ROADWAY PLANS

JUDGE ORR ROAD RV PARK AND STORAGE

EL PASO COUNTY, COLORADO

Markup Summary

JUDGE ORR ROAD RV PARK & STORAGE
COLORADO SPRINGS, COLORADO
ROADWAY OVERALL PLAN

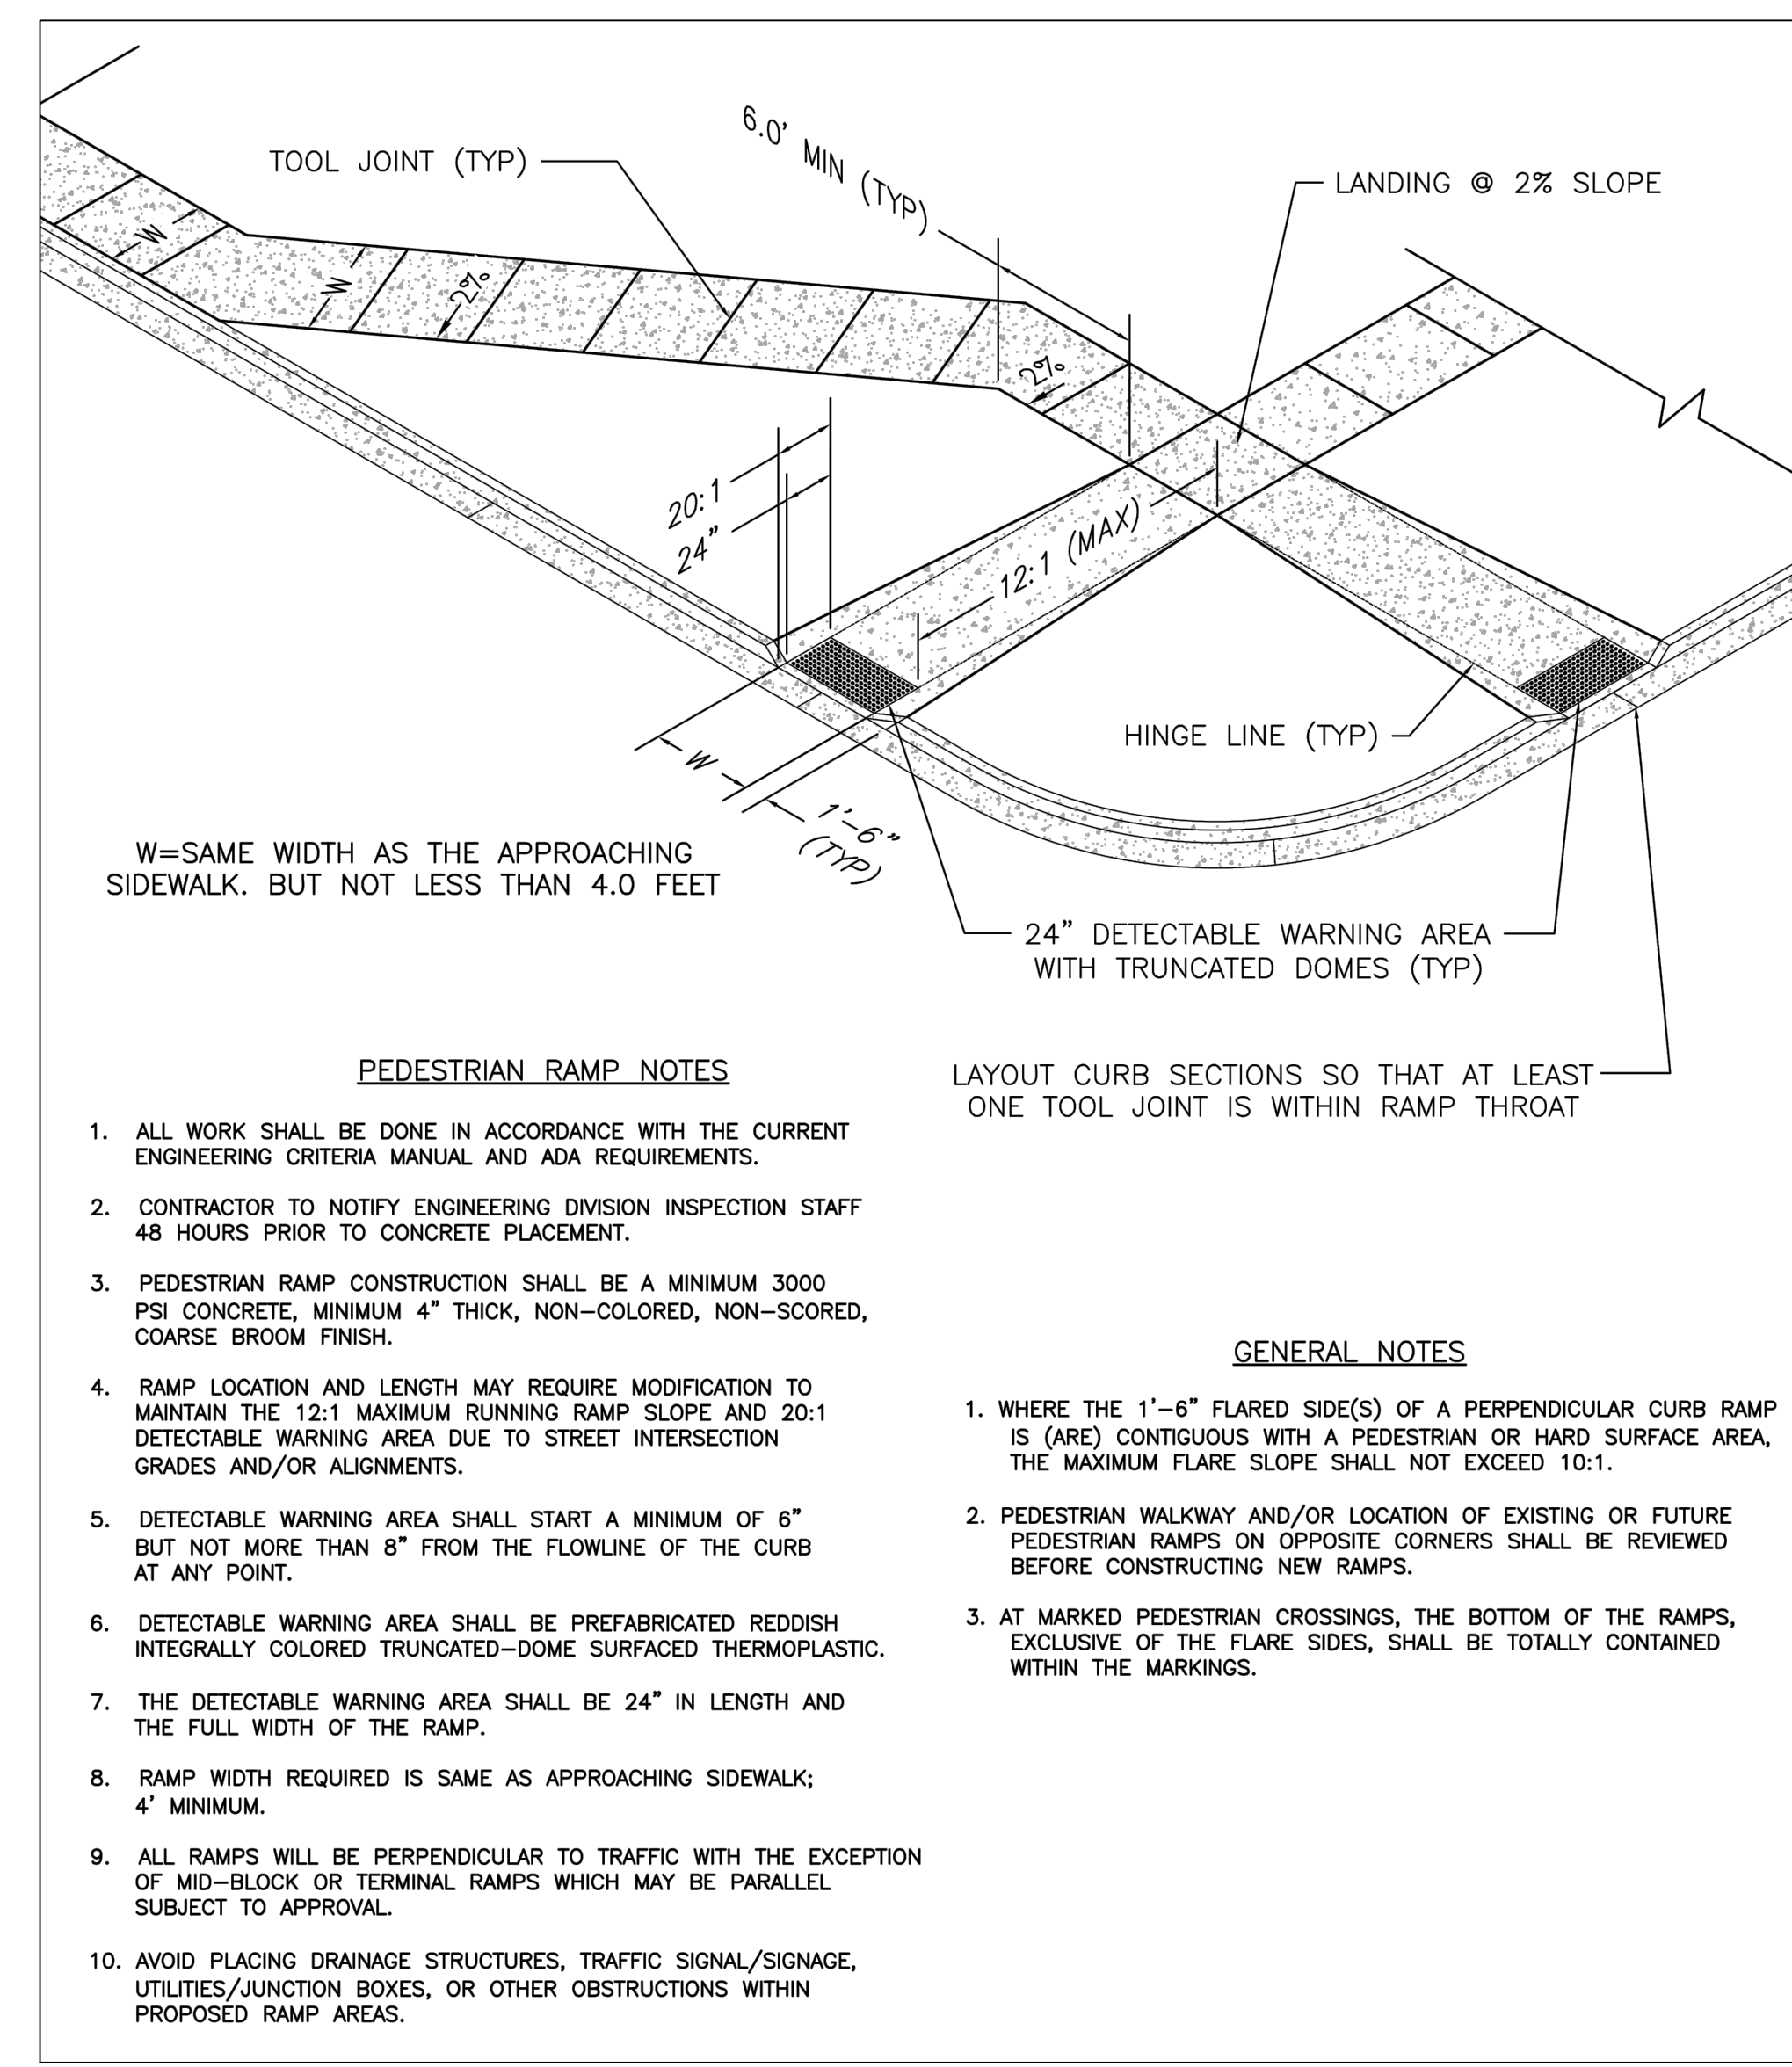
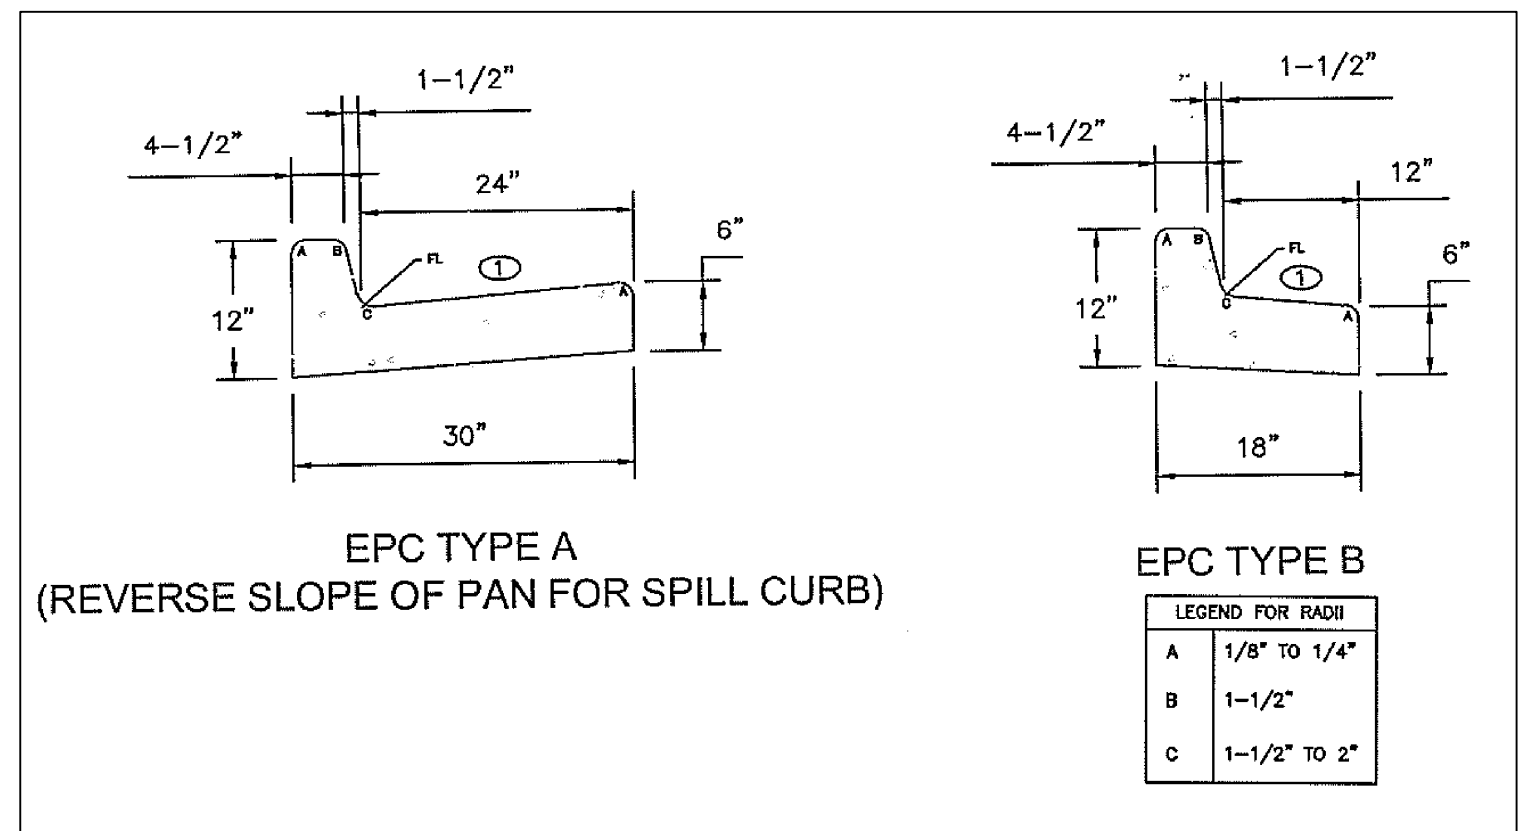
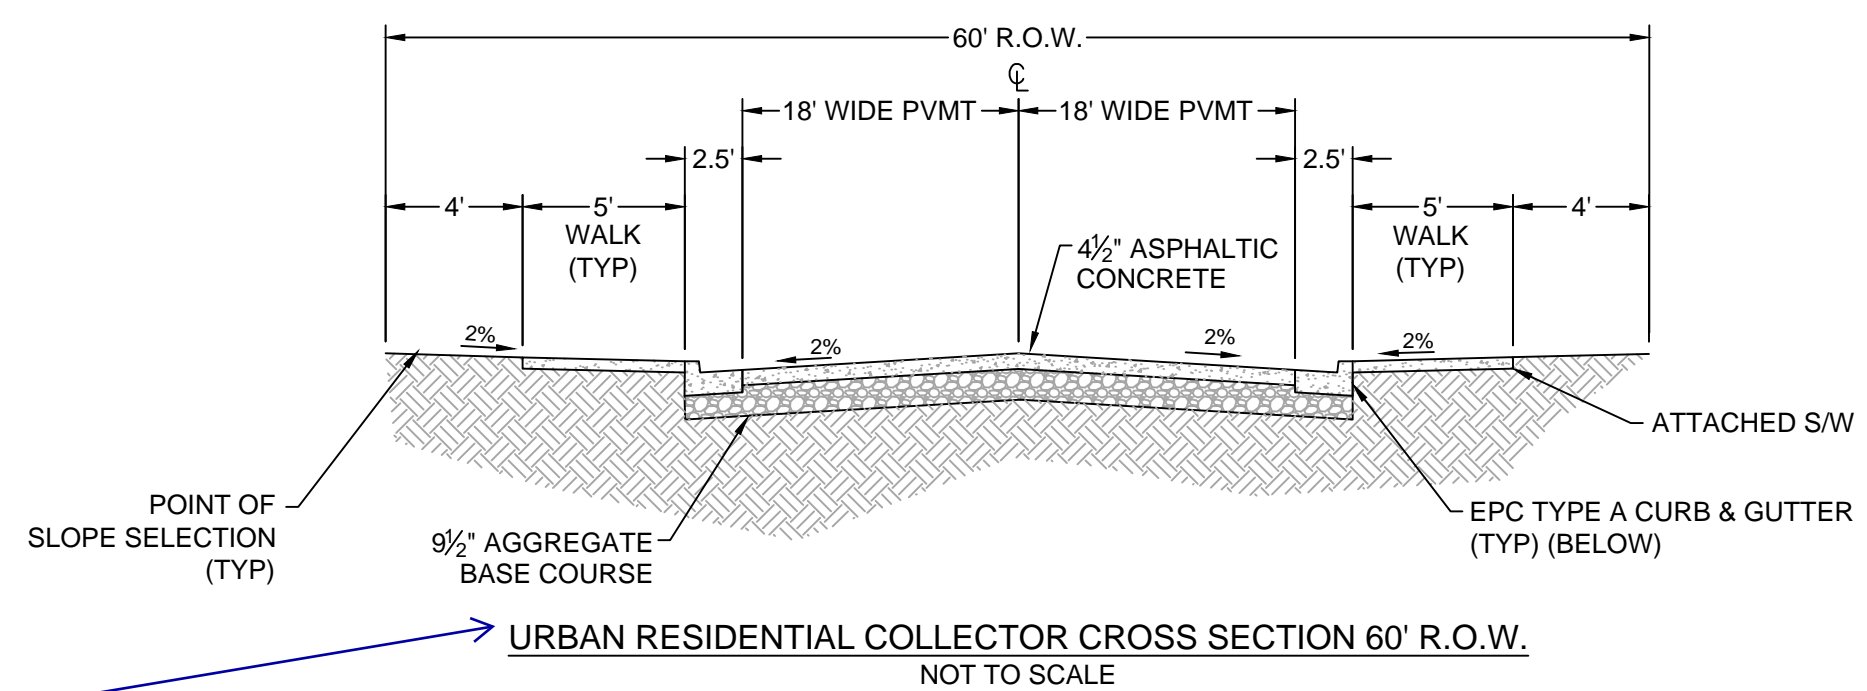
Update. This is not legible.

Revise to urban non-residential. Per ECM Section 2.2.4.B.5 Residential Collector is exclusively residential areas.
